AMENDMENTS TO THE DRAWINGS

REMARKS

FIG. 2B

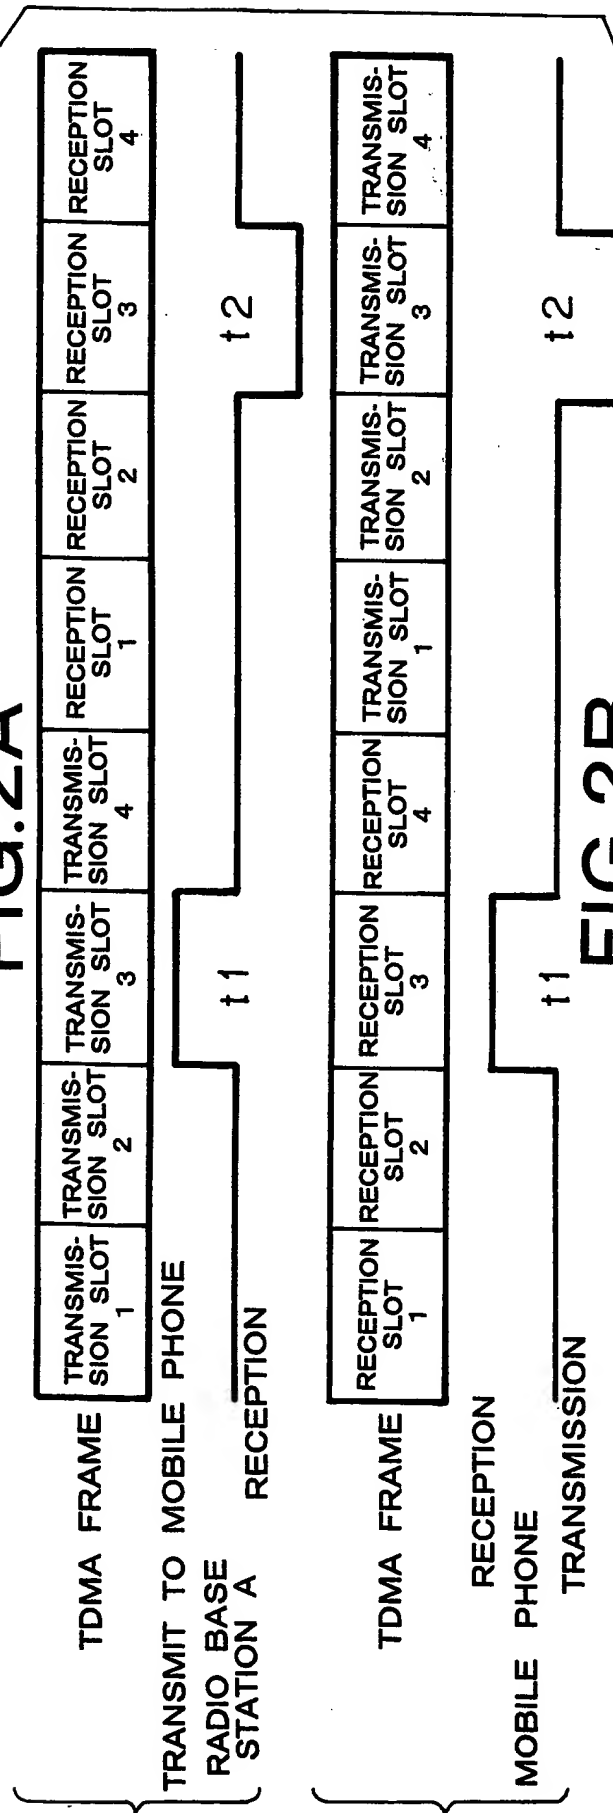
In FIG. 2B, the label “RADIO BASE STATIONS B TO D” has been replaced with the label “RADIO BASE STATION C”.
